The removal of Figure 4 necessitated changing Figures 5-8 along with changes in the specification. Also included are changes to correct for minor errors.

Version With Markings To Show Changes Made

FIG. 3

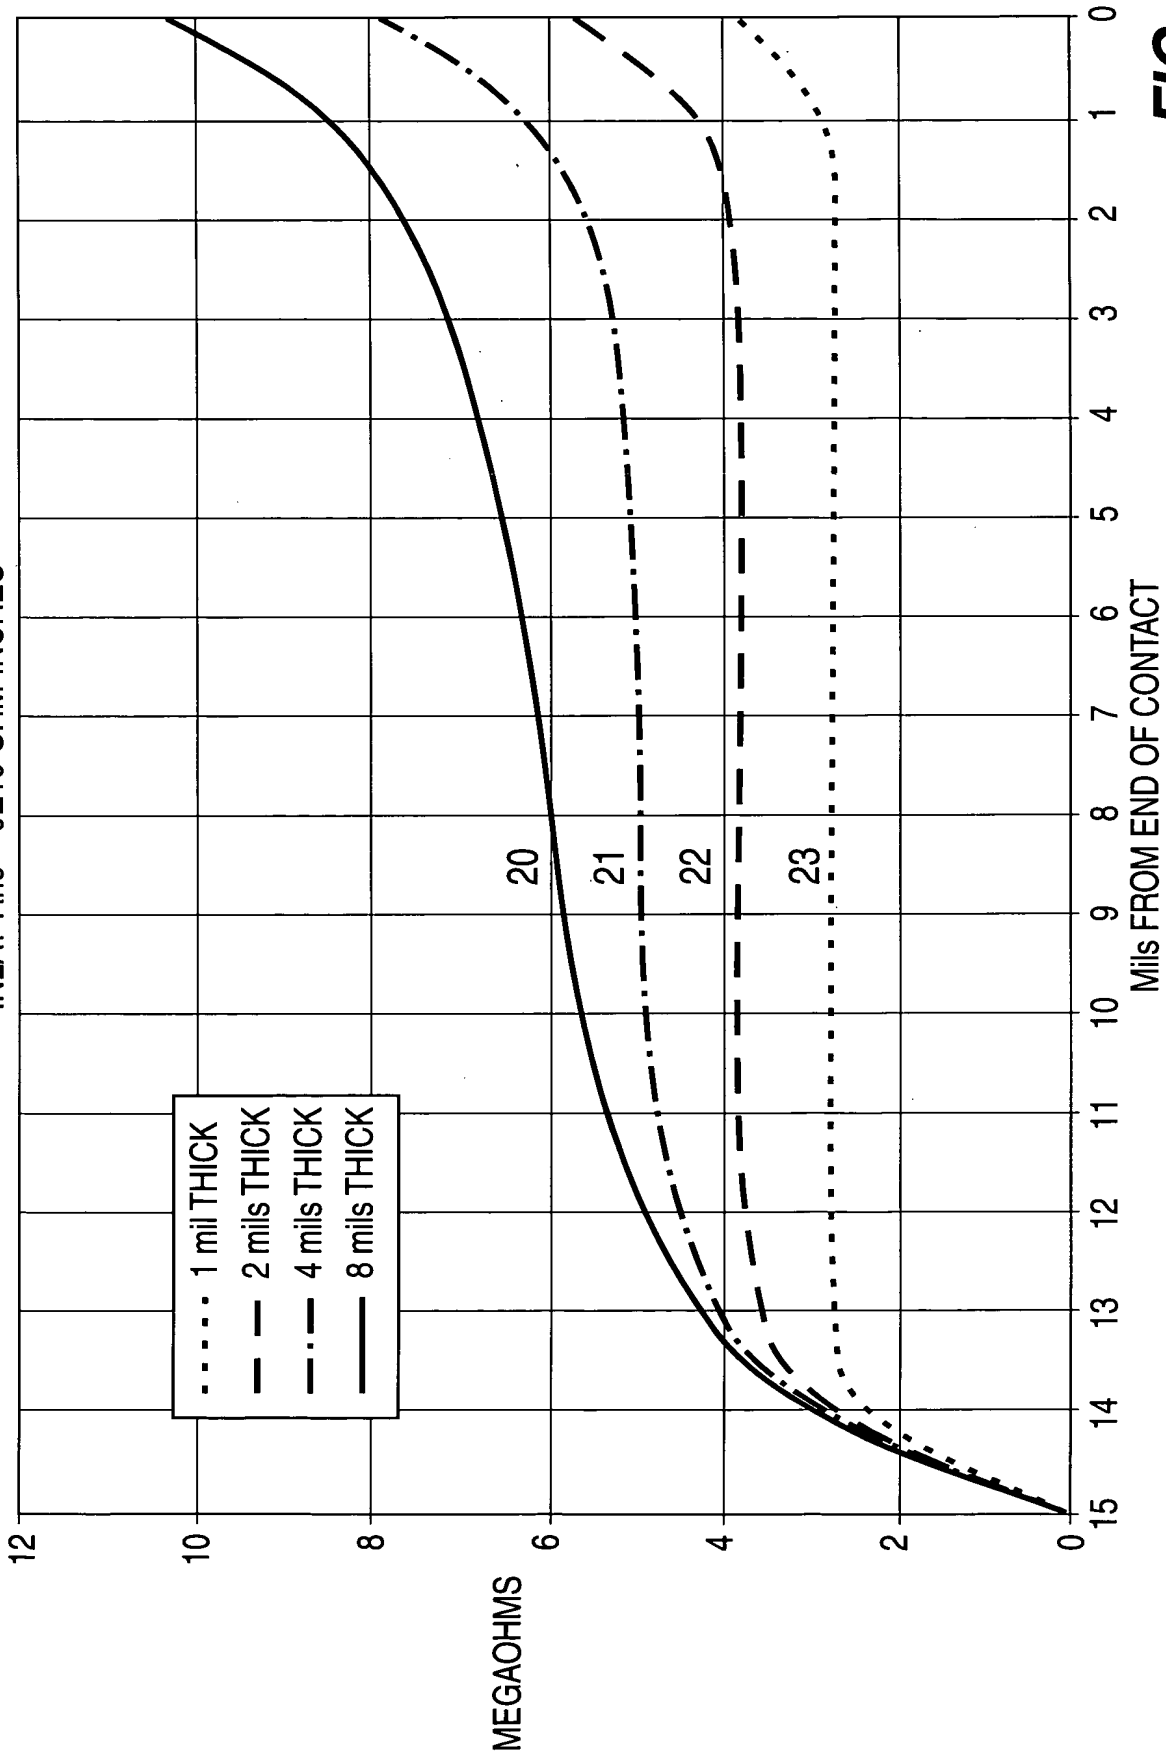
page 8, line 28: **Figure 3** is a graph of the electrical resistance as measured from the end of the plug contact **7**. This graph is based on a resistive portion **12** of a rectangular shape 15[13] mils wide and 15 mils long.

All other parameters were held constant.[The high resistive material had a resistivity of 9×10^{10} ohm-inches.] As shown, the resistance increases as the thickness of the resistive portion **12** increases. Referring to curve **20**, when a resistive portion thickness of 8 mils is used, a resistance of 10 MW is achieved at the first end **11** of the plug contact **7**, which gradually decreases until the second end **13** is reached where the resistance is nominally zero. Curves **21**, **22** and **23** illustrate that the resistance decreases with a decrease in resistive portion thickness. The shape of the curves also differs as the resistive portion thickness is changed.

FIG. 5a

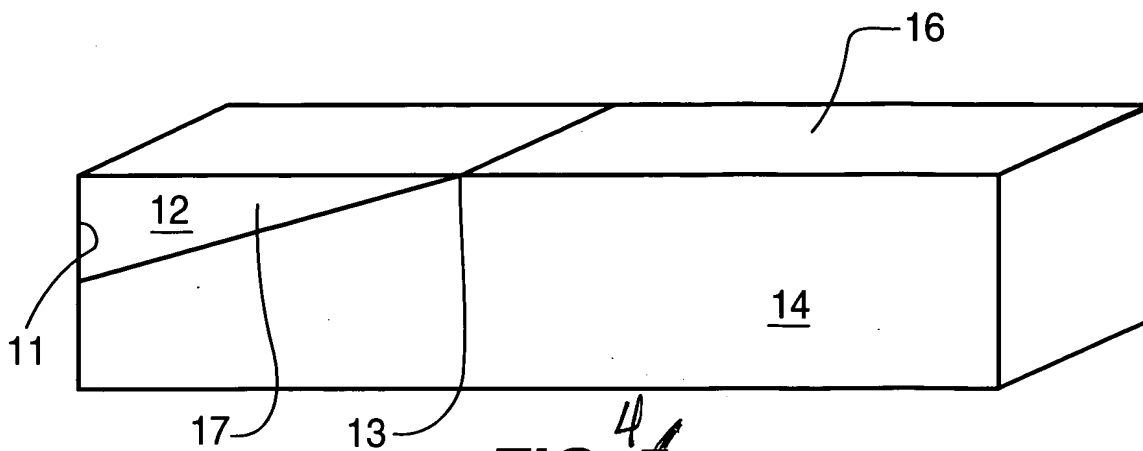
Substitute the following paragraph for the paragraph beginning at page 4, line 27: Figure 4[5]a is an alternative embodiment of the present invention with a tapered high resistive portion.

Substitute the following paragraph for the paragraph beginning at page 10, line 1: Alternative embodiments of the present invention are shown in **Figures 4[5]a-4i[5h]**. In the embodiment depicted in **Figure 4[5]a**, the resistive portion **12** has a tapered profile. By varying the shape of the tapered profile of the resistive portion [13], the resistive transition curves that result as the receptacle contact **15** passes over the resistive portion **12** can be varied as desired for a particular application.

FIG. 5b

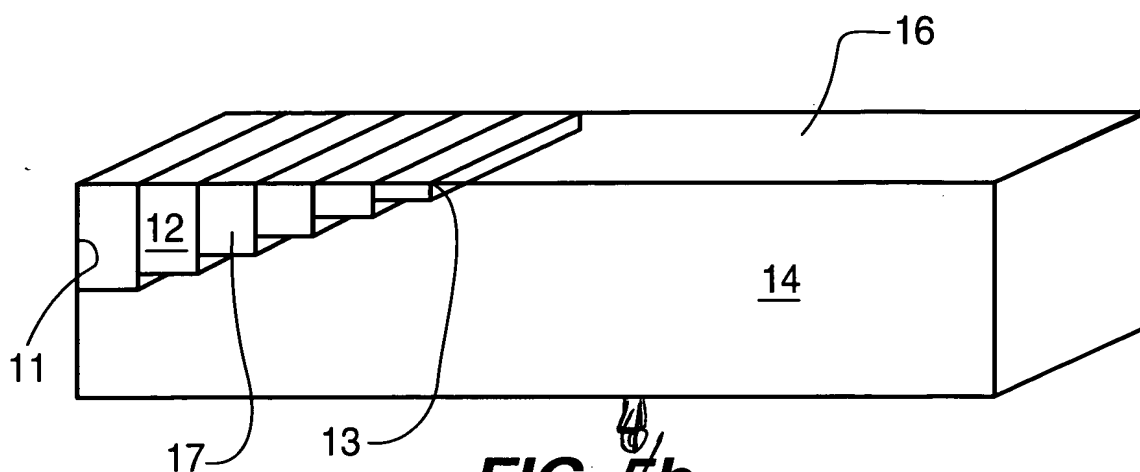
Substitute the following paragraph for the paragraph beginning at page 4, line 29: Figure 4[5]b is an alternative embodiment of the instant invention with a stepwise-tapered high resistive portion.

Substitute the following paragraph for the paragraph beginning at page 10, line 9: **Figure 4[5]b** depicts an alternative embodiment with the resistive portion **12** in a stepwise-tapered profile **17**. By varying the steps between the steps, the resistive transition curves can be varied as desired.

FIG. 5c

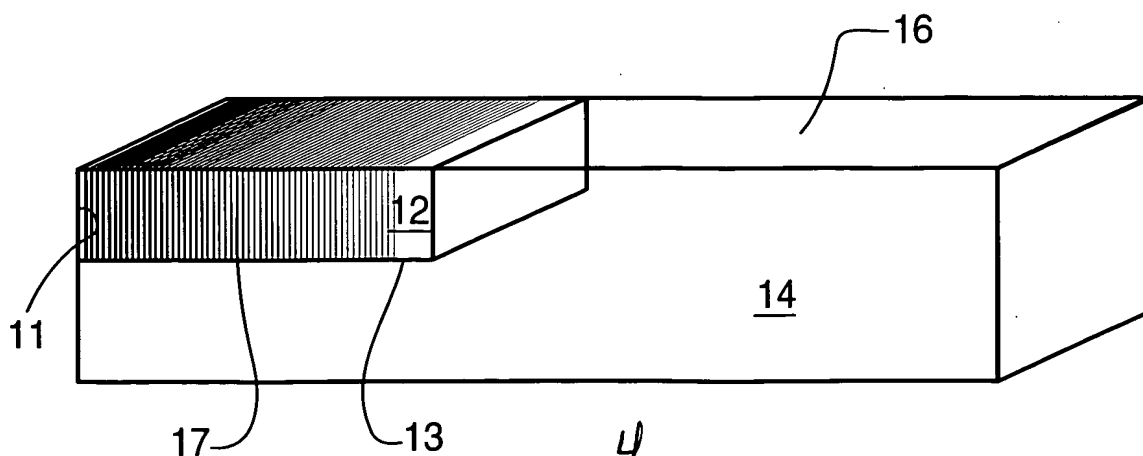
Substitute the following paragraph for the paragraph beginning at page 5, line 1: Figure 4[5]c is an alternative embodiment of the present invention with a resistive portion of mixed high resistive materials.

Substitute the following paragraph for the paragraph beginning at page 10, line 13: A third alternative embodiment is shown in **Figure 4[5]c**. The resistive portion **12** consists of two or more materials with varying resistivities.

FIG. 5d

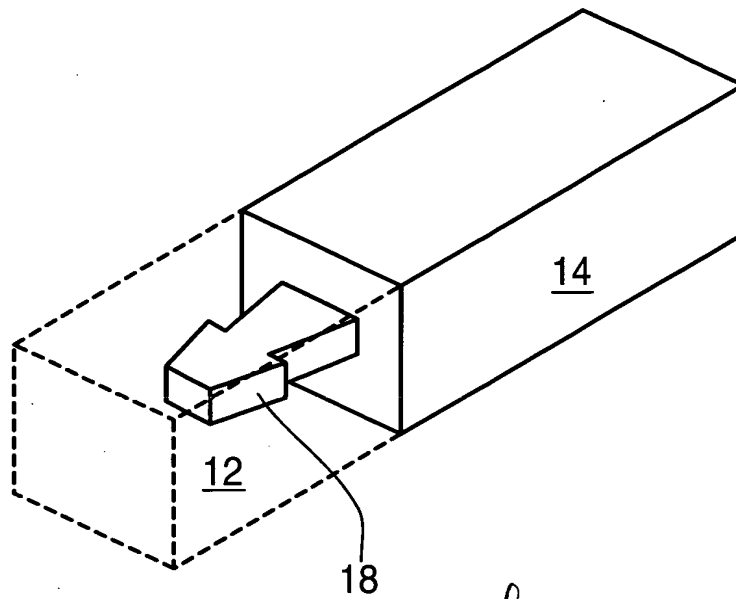
Substitute the following paragraph for the paragraph beginning at page 5, line 4: Figure 4[5]d is an alternative embodiment of the present invention with a conductive barb in the high resistive portion.

Substitute the following paragraph for the paragraph beginning at page 10, line 16: **Figure 4[5]d**, a fourth alternative embodiment shows, the resistive portion **12** extending from the conducting portion **14**. A conducting barb **18** extends from the conducting body **14** into the resistive portion **12**. A fifth alternative embodiment, **Figure 4[5]e**, has the resistive portion **12** extending into a hole **19** in the conducting portion **14**. As those skilled in the art will note many other variations are possible without departing from the spirit of the invention. These varying embodiments can be used for varying the resistive transition curves for differing applications.

FIG. 5e

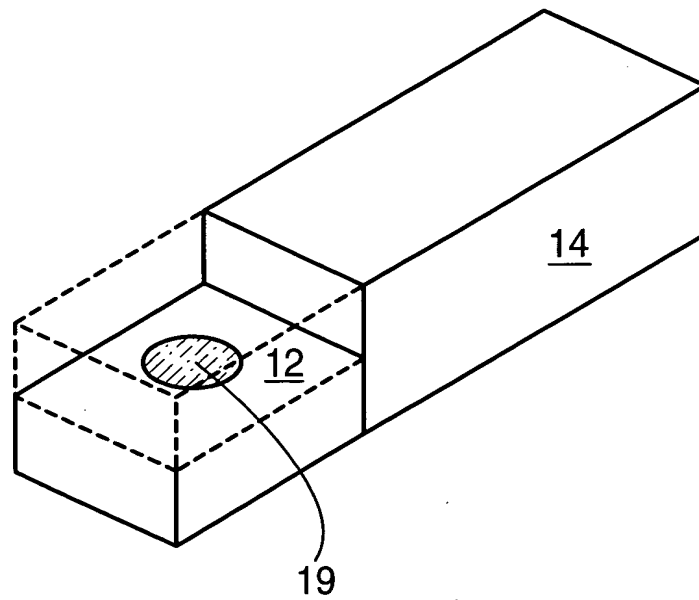
Substitute the following paragraph for the paragraph beginning at page 5, line 7: Figure 4[5]e is an alternative embodiment of the present invention with the high resistive portion extending into a hole in the conductive portion.

FIG. 5f

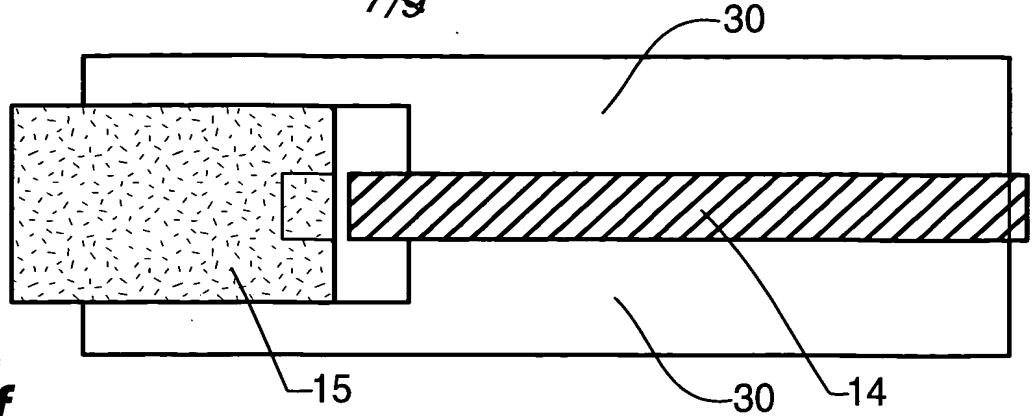
Substitute the following paragraph for the paragraph beginning at page 5, line 10: Figure 4[5]f is an alternative embodiment of the present invention with a high resistive housing.

Substitute the following paragraph for the paragraph beginning at page 10, line 27: **Figure 4[5]f** depicts a sixth embodiment. The conductive body **14** is surrounded by a high resistive housing **30**. Receptacle contact **15** first makes contact with high resistive housing **30**. As the receptacle contact **15** makes contact with conducting portion **14**, the receptacle contact sees essentially no resistance.

FIG. 5g

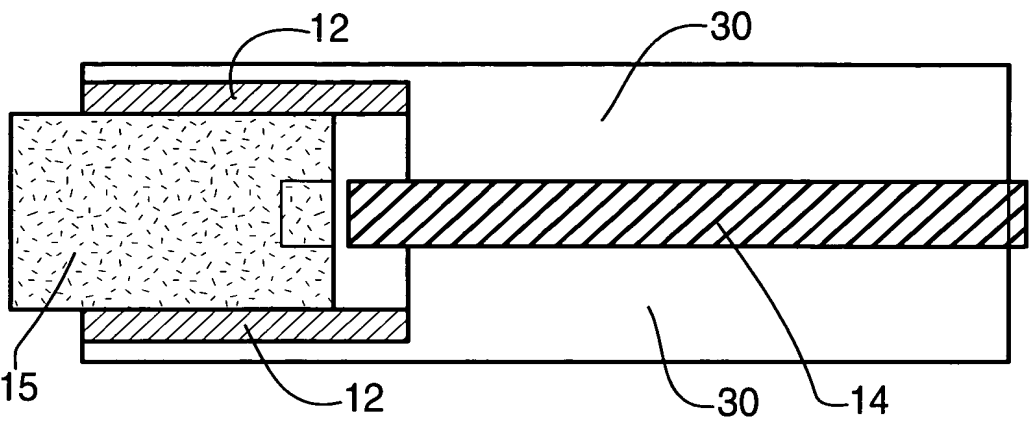
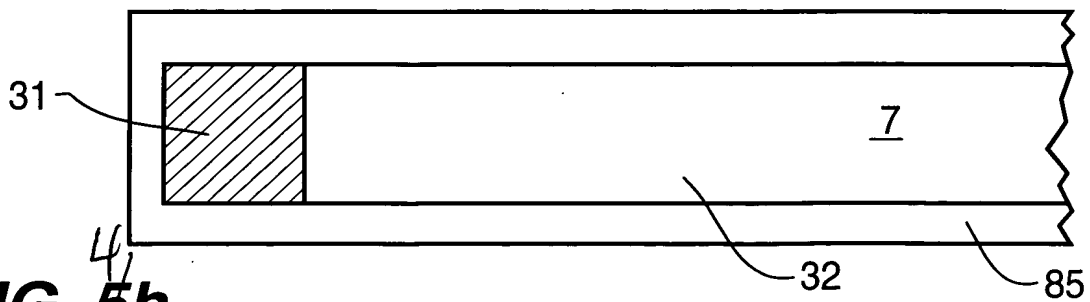
Substitute the following paragraph for the paragraph beginning at page 5, line 12: Figure 4[5]g is an alternative embodiment of the present invention with a high resistive inset in the housing.

Substitute the following paragraph for the paragraph beginning at page 11, line 1: In **Figure 4[5]g**, the housing **30** is non-conductive. However, high resistive portions **12** make initial contact with receptacle

contact 15. The high resistive portions **12** are electrically connected and may be physically connected (not shown) to conducting portion **14**.

FIG. 5h

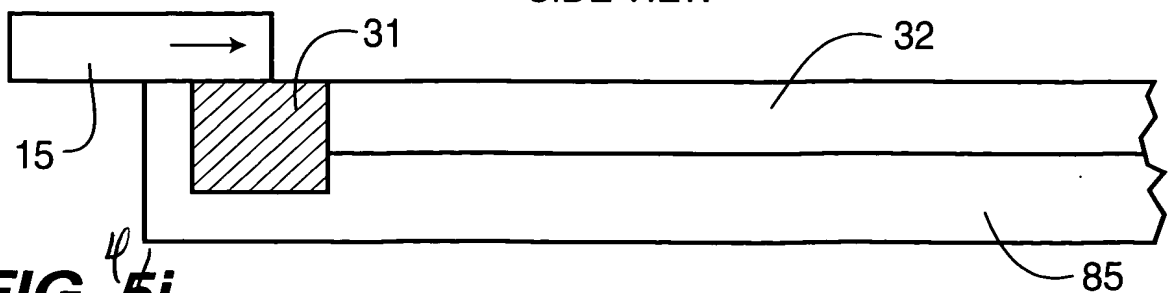
Substitute the following paragraph for the paragraph beginning at page 5, line 15: Figures 4[5]h and 4[5]i are an alternative embodiment of the present invention with a high resistance inset in the housing.

Substitute the following paragraph for the paragraph beginning at page 11, line 6: Figures **4[5]h** and **4[5]i** depict a plug contact **7** having a housing 85 surrounding a first high resistance **31** portion and a second low resistance portion **32**. Upon full mating, the receptacle contact **15** is in full contact with the low resistance portion **32**.

FIG. 6

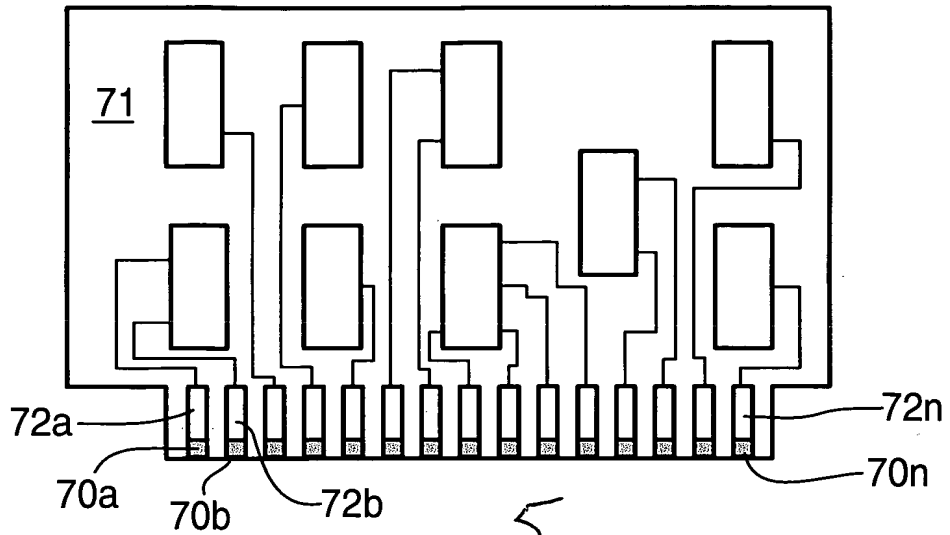
Substitute the following paragraph for the paragraph beginning at page 5, line 18: Figure 5[6] is an illustration of the instant invention utilized on a circuit board.

Substitute the following paragraph for the paragraph beginning at page 11, line 11: Figure **7[6]** illustrates that the present instant invention may also be used with the contacts on a printed circuit board. The resistive portions **70a-70n[A-N]** of the instant invention may be employed in one or more plug contacts **72a-72n[A-N]** on a conventional printed circuit board **71**. Figure **6[7]** shows that the present invention may be adapted to various shaped applications. For instance, a plug **83** with a cylindrical shape with a resistive portion **81** and conductive portion **82**. Receptacle contacts **84** within the receptacle **85** make contact with the resistive portion **81** prior to the conductive portion **82**.

FIG. 7

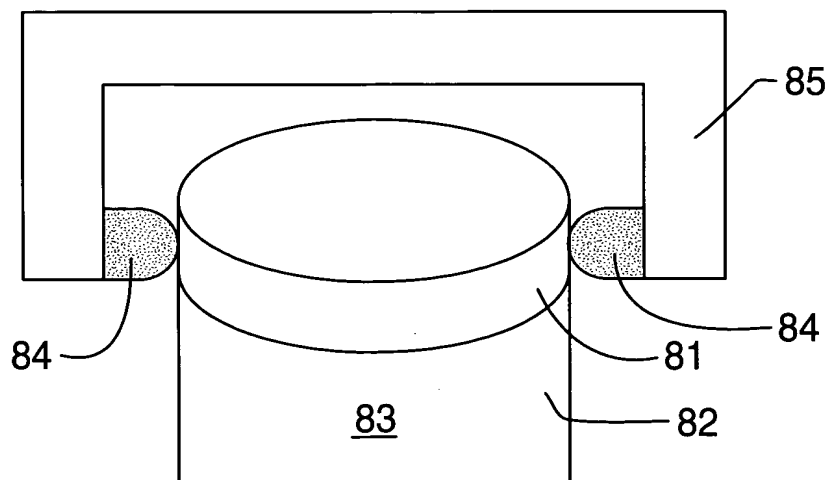
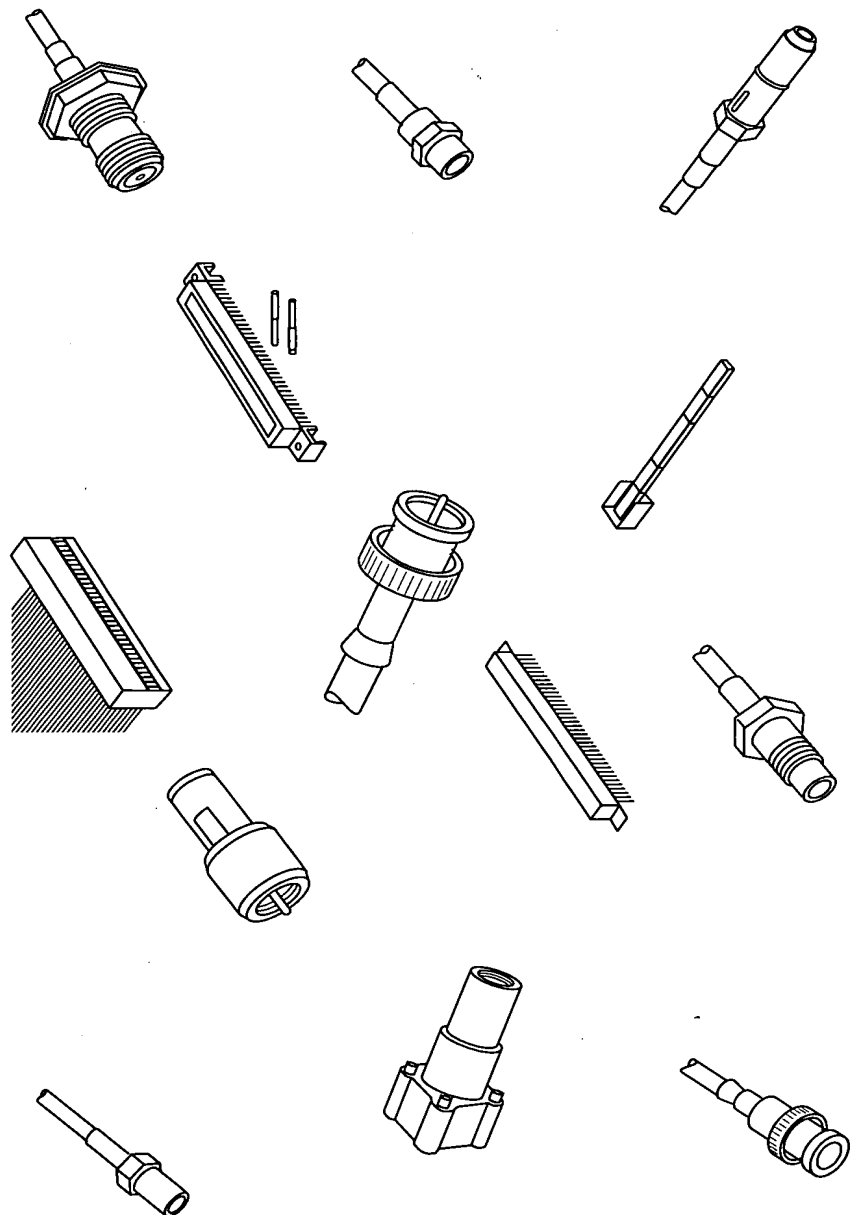
Substitute the following paragraph for the paragraph beginning at page 5, line 20: Figure 6[7] is an illustration of the instant invention being used on a cylindrical connector.
